SAN GABRIEL RIVER WATERSHED PROJECT TO REDUCE RIVER DISCHARGE IN SUPPORT OF INCREASED RECYCLED WATER REUSE

Final Environmental Impact Report
State Clearinghouse No. 2018071021

Prepared for
Sanitation Districts of Los Angeles County

November 2019

Figure 3-1: San Gabriel River Flow Study Periods

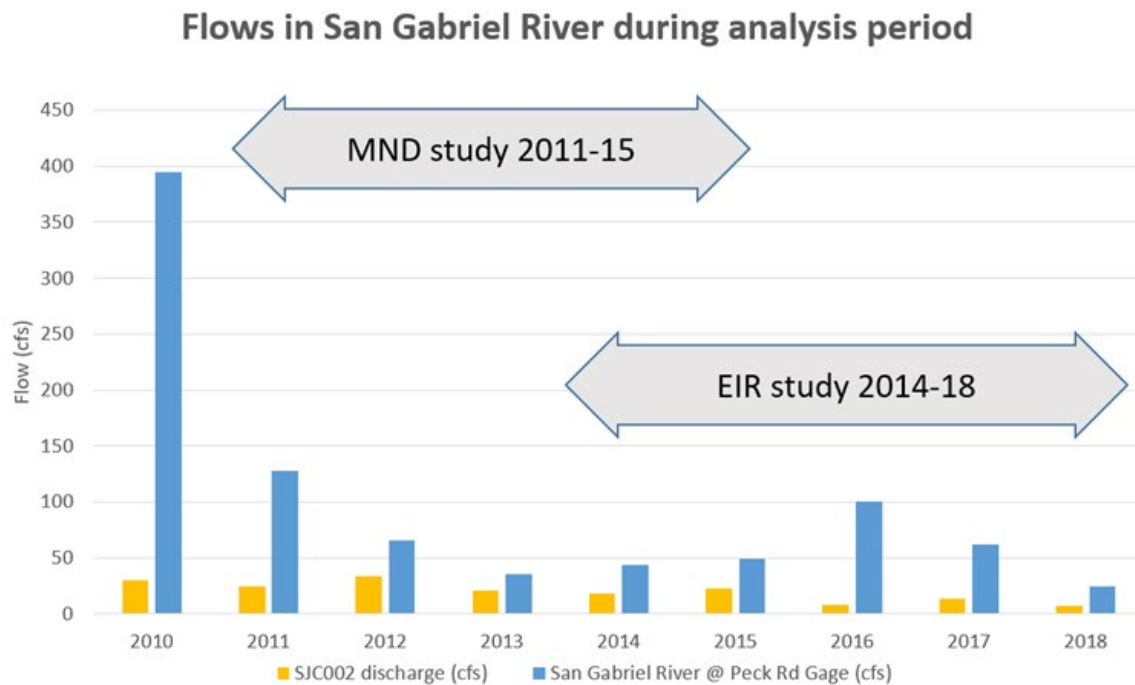
Mitigation Measure: Given the recent substantial reduction in baseline discharge levels, we request that the DEIR clarify the discrepancy in the baseline conditions and acknowledge that discharge levels may need to be higher than the current average annual discharge levels "to ensure that the quantity and quality of riparian and wetland habitat currently supported by wastewater discharges is maintained at or above baseline levels" (Mitigation Measure BIO-1).

As described in the Draft EIR (Sections 3.1 and 3.2), the Sanitation Districts conducted two hydrology studies, one that characterized existing and historical flows in the river (Draft EIR, Appendix E2, Hydrology Report 2018) and one that evaluated the relationships of existing surface water flows and ecological values exhibited in the channel and estimated potential effects to the ecology that may result from reduced discharges (Draft EIR, Appendix E1, Hydrology Report 2019). According to the results of the 2018 Hydrology Report and 2019 Hydrology Report, discharges from the San Jose Creek WRP have varied significantly over time. The current habitat in the river channel reflects the recent water availability and represents the baseline condition at the time of the NOP. It should be noted that a lead agency has considerable discretion in determining the baseline physical conditions by which a lead agency determines whether an impact is significant, which are ordinarily “the physical environmental conditions in the vicinity of the project, as they exist at the time the notice of preparation is published, or if no notice of preparation is published, at the time environmental analysis is commenced, from both a

Figure 3.1-1
Project Area

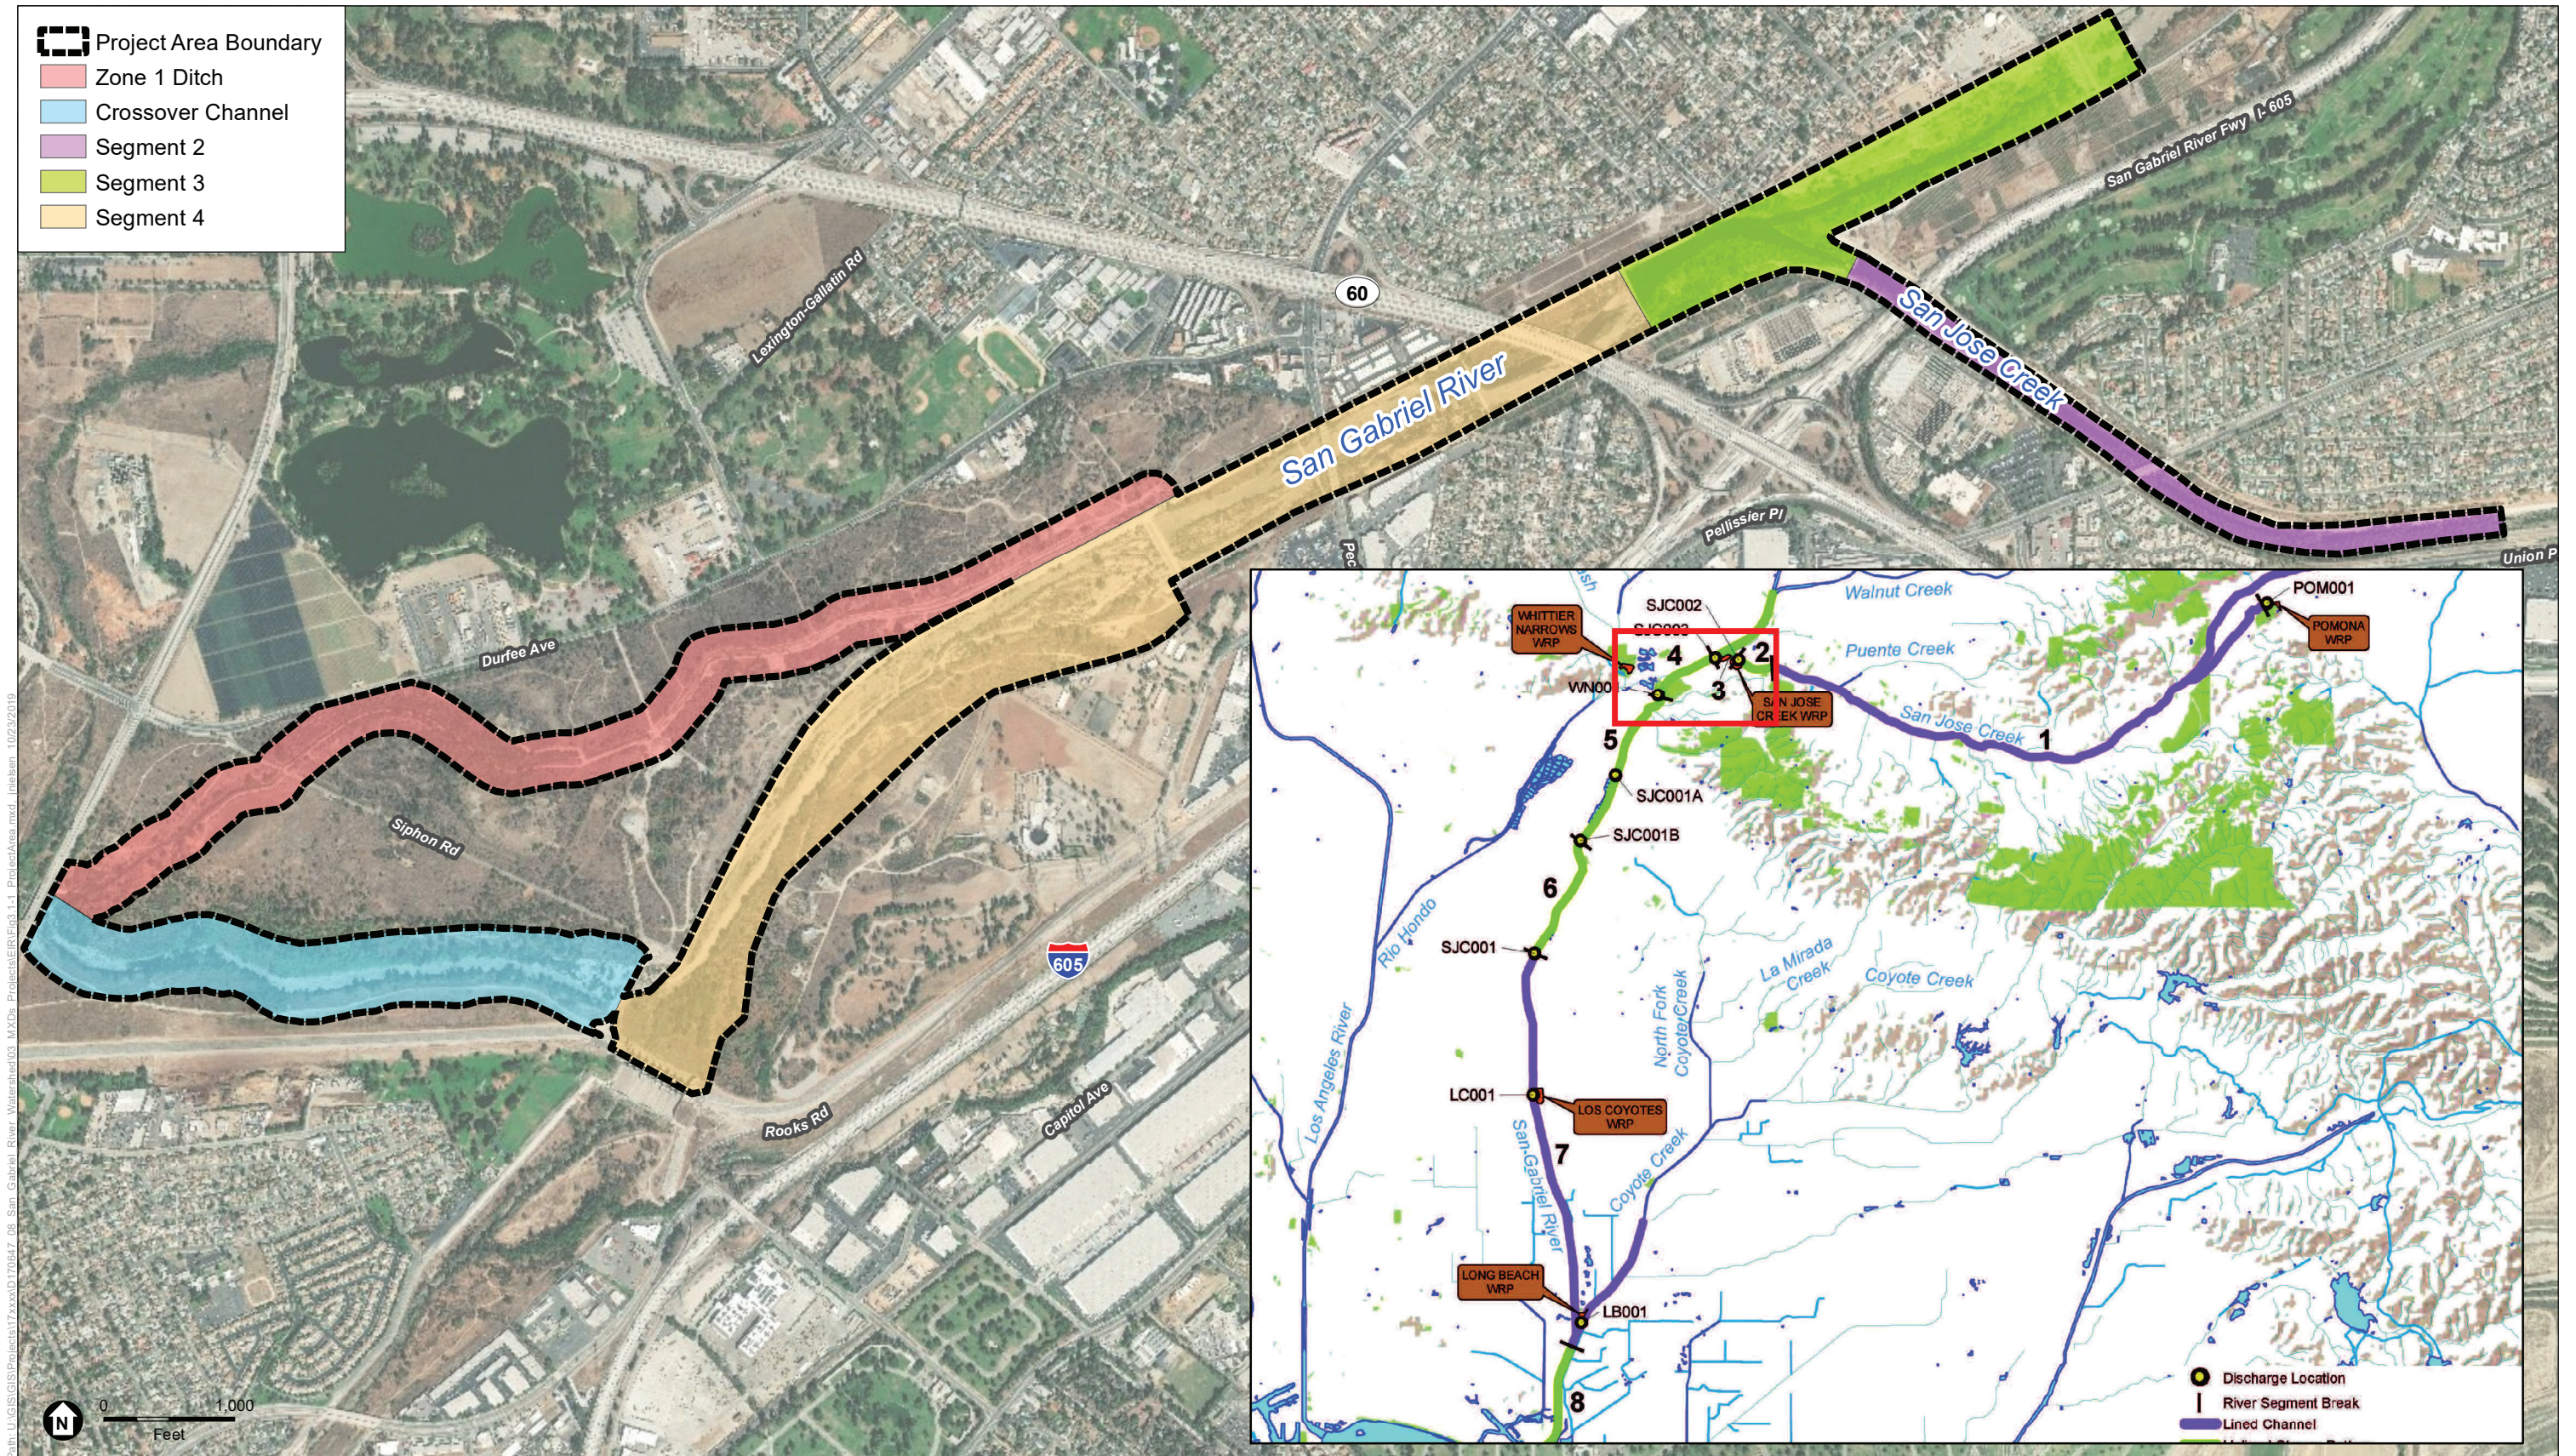
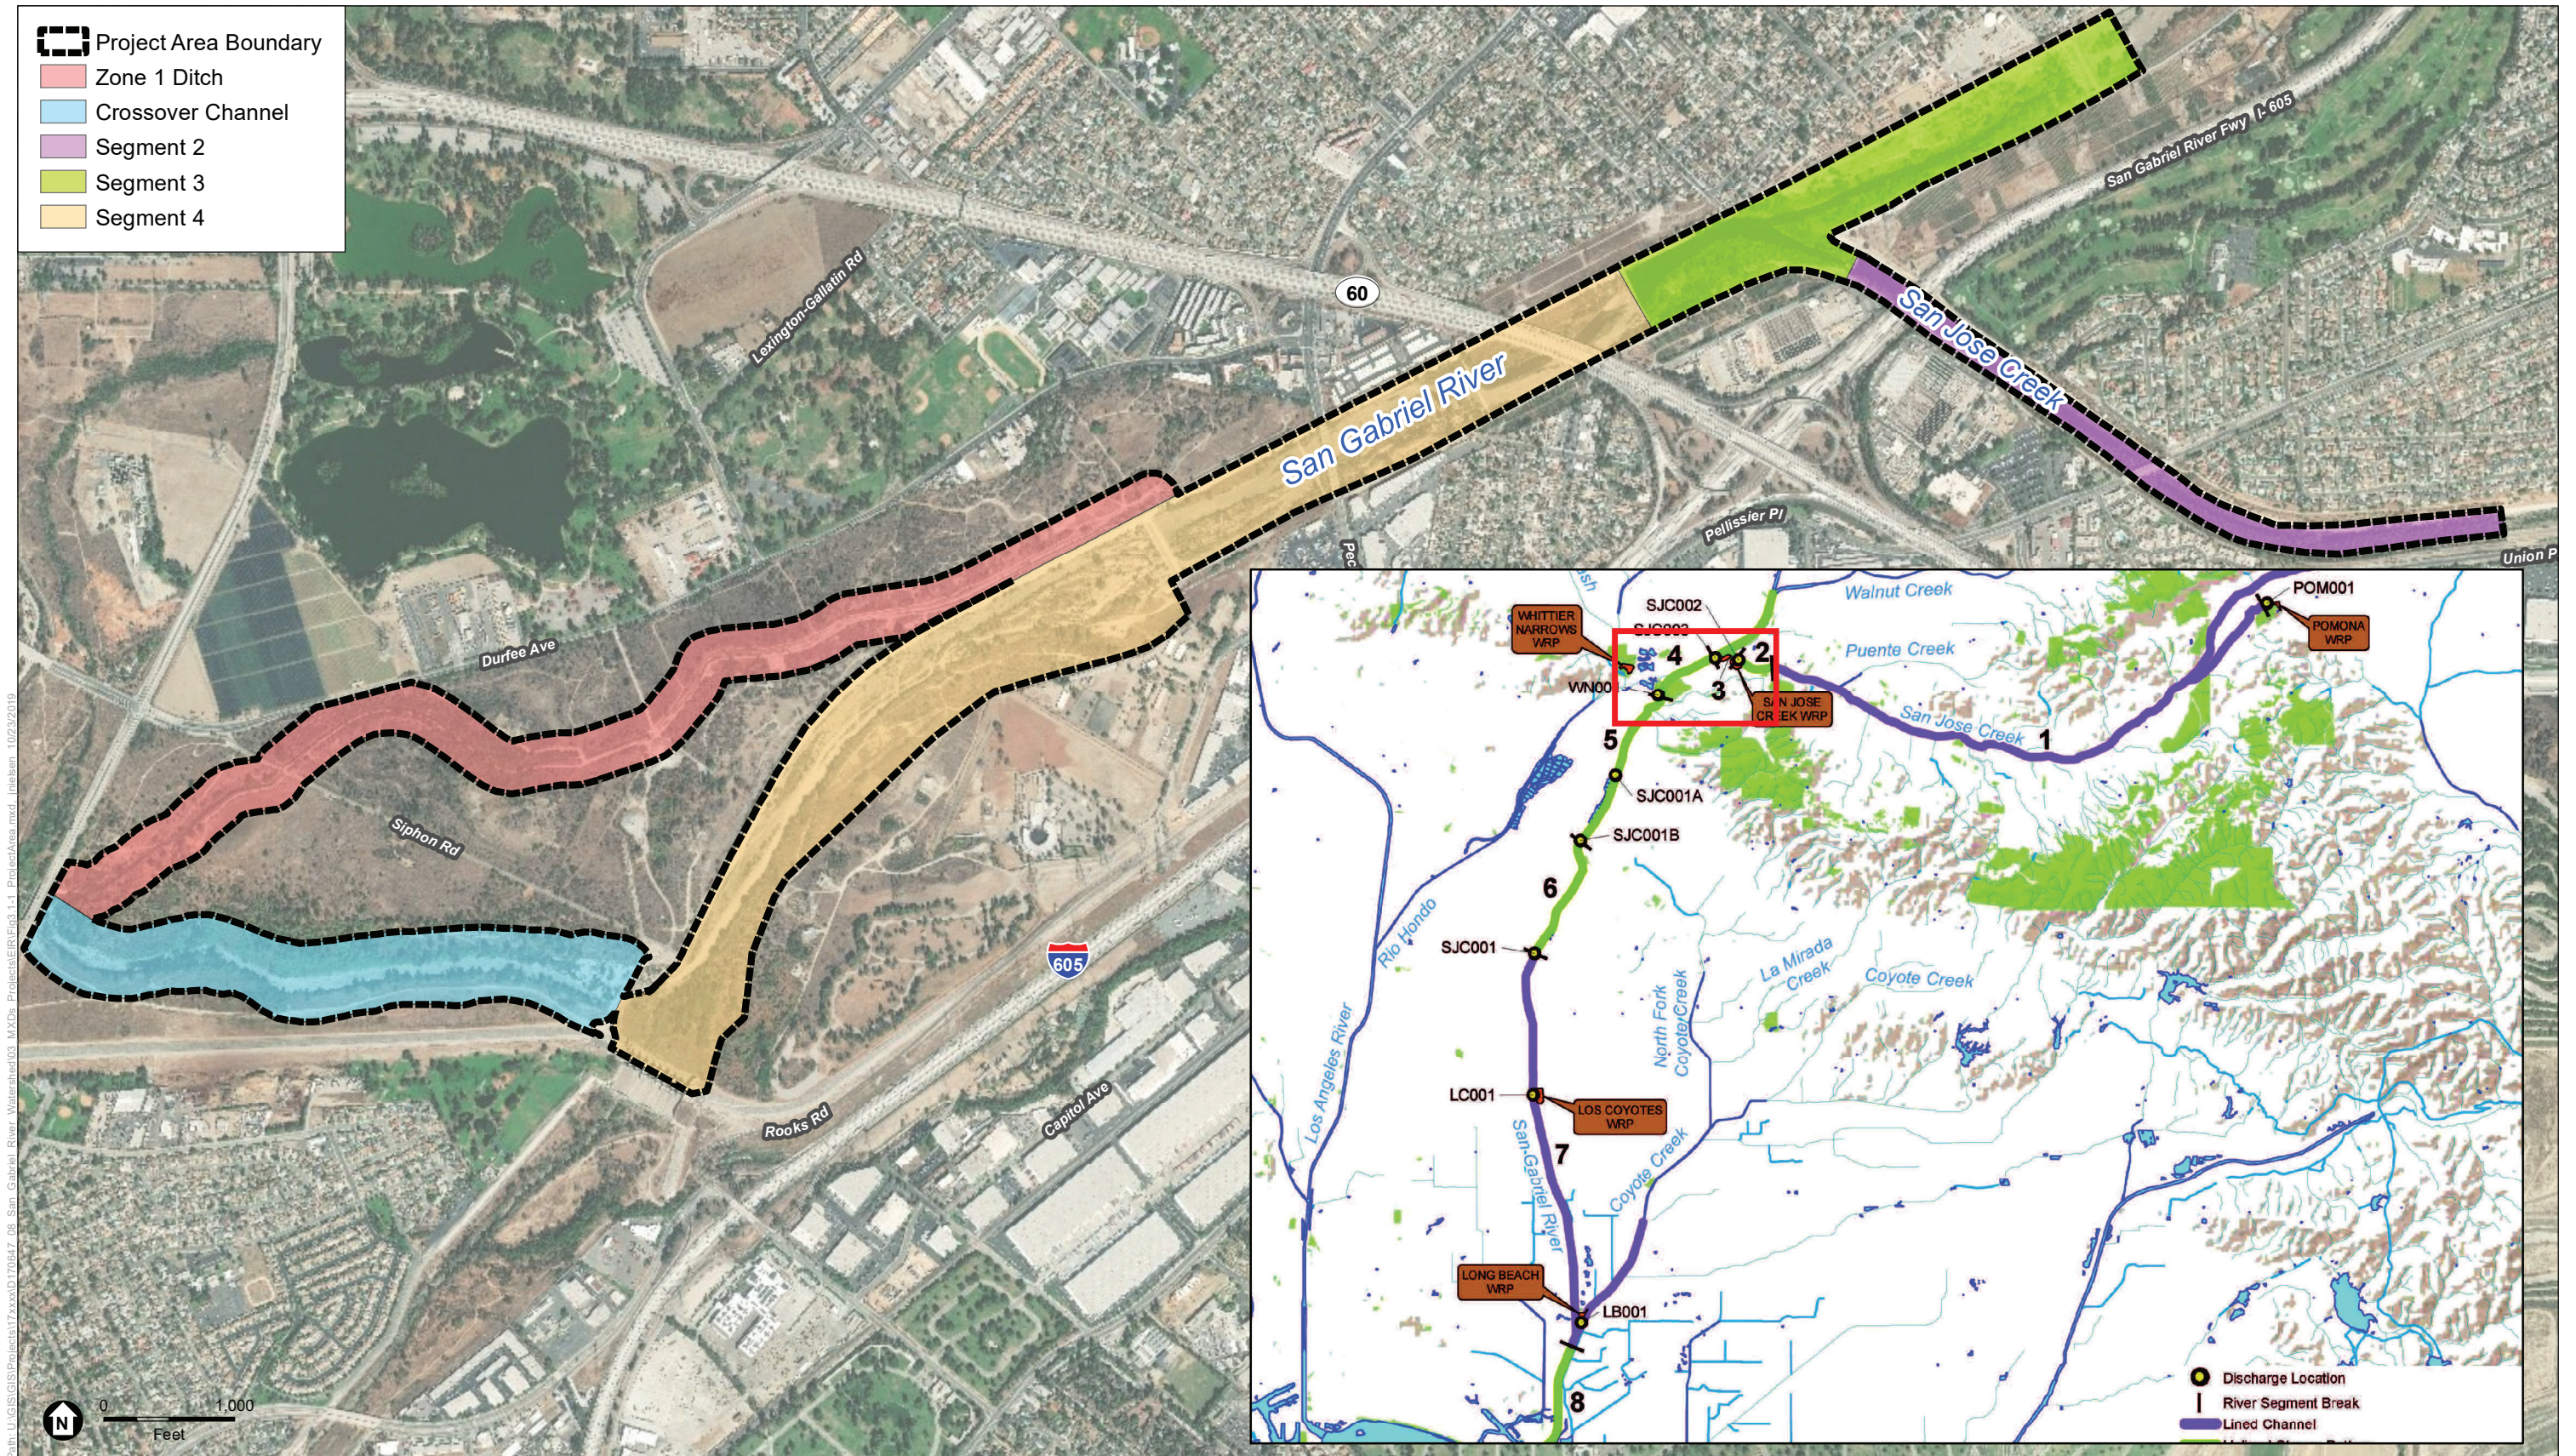
6. Page 3.1-7: Figure 3.1-1 appears to combine the delineation of Zone 1 ditch and crossover channel, and label it as Zone 1 ditch. The crossover channel should be delineated and labeled separately from Zone 1 ditch. 4-F

The comment states that on Page 3.1-7, Figure 3.1-1 appears to combine the delineation of Zone 1 ditch and crossover channel, and labels it as Zone 1 ditch. The comment suggests that the crossover channel be delineated and labeled separately from Zone 1 ditch.

To respond to Comment 4-F, Figure 3.1-1 of the Draft EIR has been revised to locate the crossover channel as shown on the next page.

Refer to revised Figure 3.1-1 at the end this Chapter.
